Agenda Item # 3

BOA-003847-2026

407 Hillcrest Road

APPLICATION NUMBER	6785	DATE	October 1, 2026
APPLICANT	Geographic Consulting, LLC		
REQUEST	Use, Access and Maneuvering, Residential Buffer, Pedestrian Connection, and Reduced Landscape Area

SITE PLAN

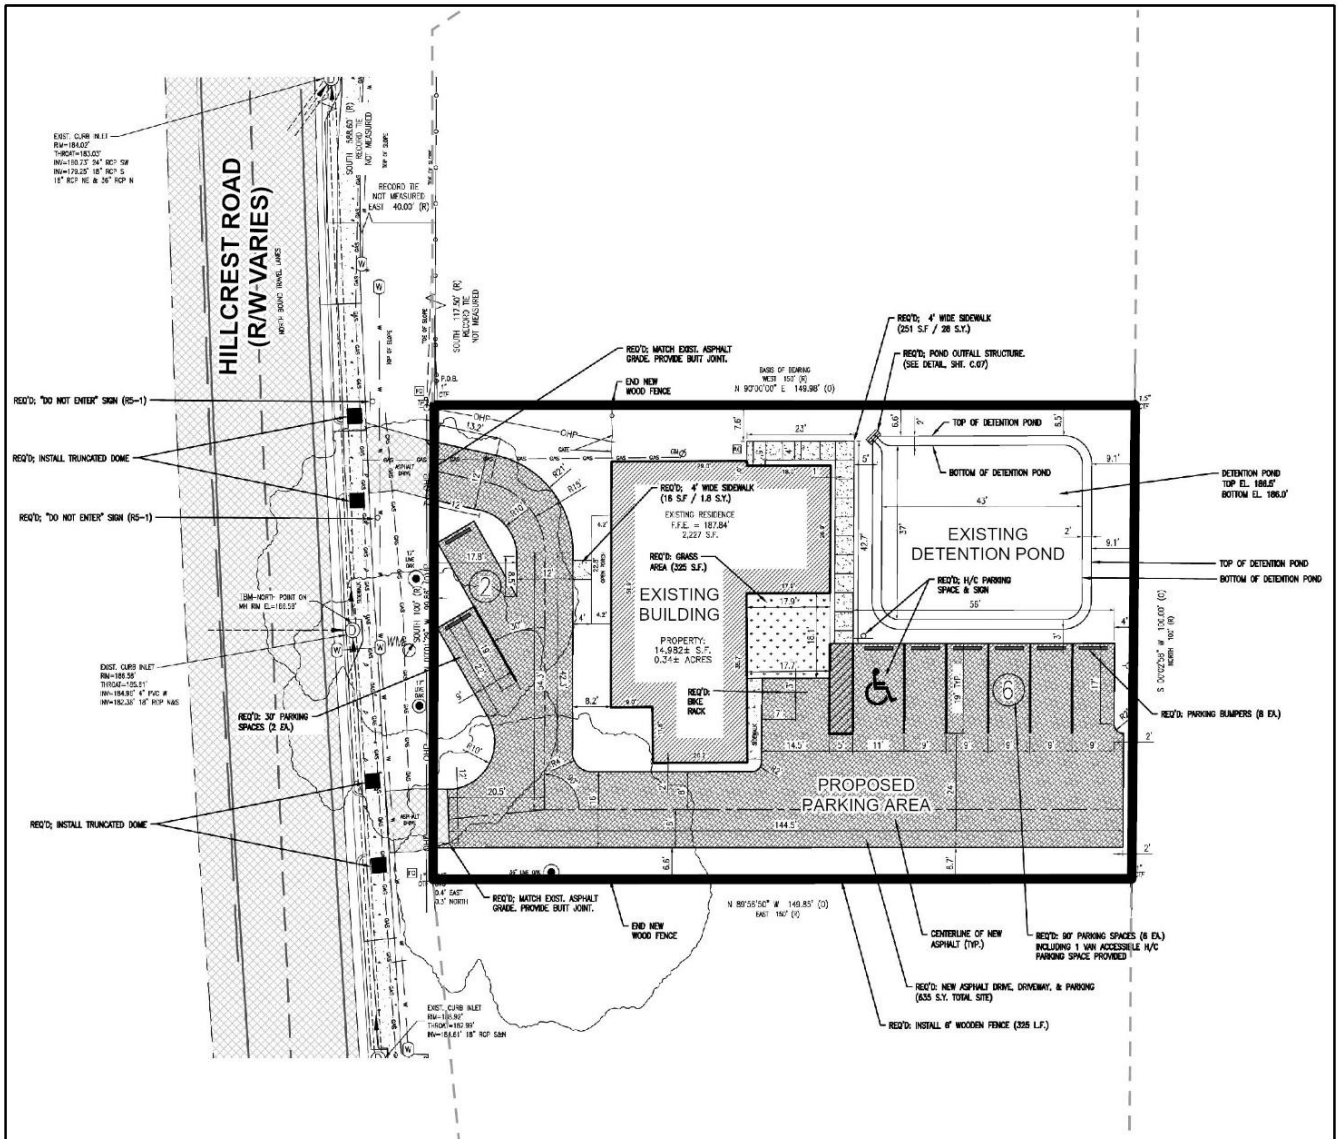
The site plan submitted indicates that the existing substandard drive will be widened to twelve (12) feet and paved. The double-entry will be retained. As such, the driveway should be restricted to one-way traffic entering from the South side and exiting to the North side, if approved. Two (2) compliant parking stalls are proposed in the front yard. Proposed access to a rear yard parking area would be via a substandard 16-foot wide two-way drive along the South side of the site adjacent to the existing dwelling. This drive would expand to a standard 24-foot width behind six (6) proposed compliant parking stalls. The site is required six (6) parking spaces, and a total of eight (8) are proposed.

The site plan indicates a bicycle parking area but does not specify the parking count. As the building would require two (2) bicycle parking spaces, the site plan should be revised to indicate such, if approved.

The site plan indicates a wood fence along the North and South sides of the site, but none along the East (rear). As all three are adjacent to residentially zoned properties, the site plan should be revised to also indicate a wood privacy fence along the East of the site, with all indicated to be six (6) feet high. The site plan indicates that the fences along the North and South sides of the site would stop even with the front of the dwelling. The six-foot (6') height should continue to the 25-foot front setback line, at which point it should reduce to a three-foot (3') height to the front property line.

The privacy fences are only part of the required residential buffer. Section 64-3-8 of the UDC requires the buffer to be ten (10) feet wide and consist of a wall or fence, or screen planting, or a combination of both. As proposed, there is no ten (10) foot wide buffer along the North, East or South property lines. However, site constraints could possibly be considered as factors restricting the inclusion of the residential buffers.

The applicant requests relief from the requirement of Section 64-3-3.B. of the UDC to provide a pedestrian connection from the public sidewalk within the right-of-way to the main building entrance. However, no justification for such is provided, and the site plan does not indicate any topographical feature restricting the inclusion of such.

Pertaining to the Landscaping Variance request, calculations provided on the site plan indicate that both the total and frontage landscaping percentage requirements will be met. Tree planting requirements will also be met due to the existing Live Oaks on site which will be retained and credited toward the requirement. As such, Tree Planting and Landscape Area Variances are unnecessary.

- 1) Revision of the site plan to mark the driveway as one-way in from the South and one-way out at the North;
- 2) Revision of the site plan to indicate two (2) bicycle parking spaces on the designated parking rack;

- 3) Revision of the site plan to provide a six-foot (6') high wood privacy fence along the East (rear) of the site;
- 4) Revision of the site plan to indicate the wood privacy fences along the North and South sides of the site are six (6) feet high to the 25-foot front yard setback line, then dropping to three (3) feet high continuing to the front property line;

- 5) Revision of the site plan to provide a compliant Pedestrian Connection as required by Section Section 64-3-3.B. of the UDC;
- 6) Submission to and approval by Planning and Zoning of a revised site plan prior to the issuance of permits for development;
